**BOARD OF COMMISSIONERS OF THE PORT OF NEW ORLEANS**  
**NOTE TO PERSPECTIVE BIDDERS**  
**CONTRACT FOR**  
**HARMONY STREET WHARF**  
**ROOF REPLACEMENT**  
**DAMAGED BY HURRICANE KATRINA**

July 2, 2009

ADDENDUM NO. 1

SECTION 4  
SCALE 1"=1'-0"  
4.8A/8A

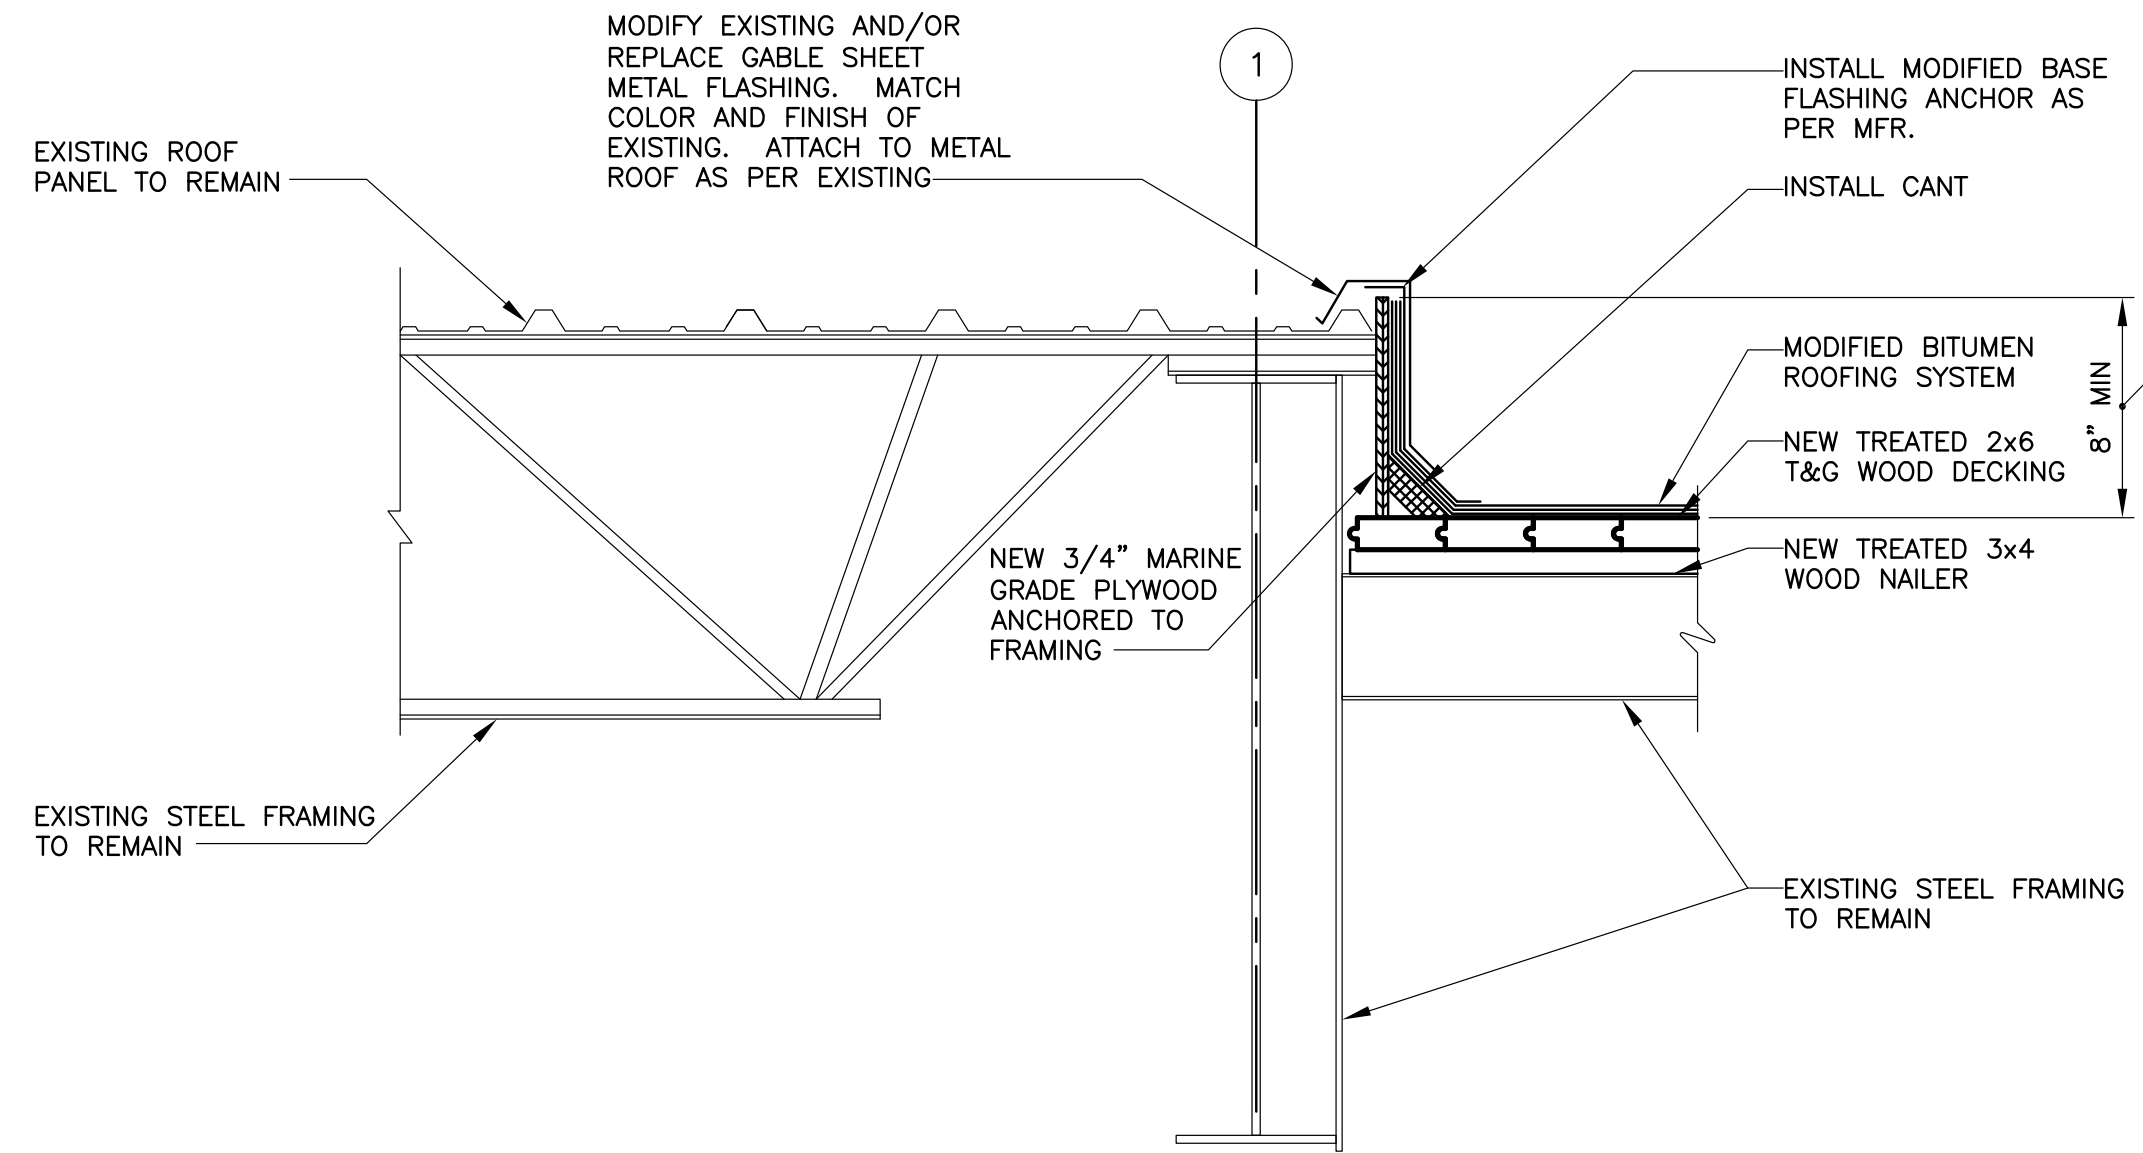
- A: Detail 2 on drawing 7 has been modified to provide reference for cowl dimensions. Revised drawing is part of this addendum.
- Q: Plan # 9 No detail or specs to modify Metal Cladding and is installing 3/4" plywood in our scope of work? Also no where in price schedule.

- A: Drawing 8A has been added to address these issues and is part of this addendum. In addition, a bid item has been added for the plywood.
- Q: Plan # 9, No detail on saddle, is there a detail and/or pictures of this area?

- A: Drawing 8A has been added to address these issues and is part of this addendum.

NOTE: AREAS OF THE ROOF WHERE FLASHING HEIGHTS ARE LESS THAN 8" ON EITHER SIDE OF THE COLUMN LINE No. 1, THE ROOFING ON BOTH SIDES NEEDS TO BE FLASHED WITH CUSTOM FABRICATED 24 GA. ST. STEEL, POP-RIVETED SADDLE WITH ALL JOINTS SOLDERED COMPLETE. FLASHING MUST BE INSTALLED TO SHED WATER FROM HIGH POINT TO LOW POINT. LAPS TO EXTEND 6" MIN. ALL ROOFING, FLASHING ON ASSOCIATED ITEMS MUST BE REMOVED, MODIFIED, OR REPLACED WITH LIKE IN KIND TO ACHIEVE A FULLY FLASHED WATER TIGHT DETAIL.
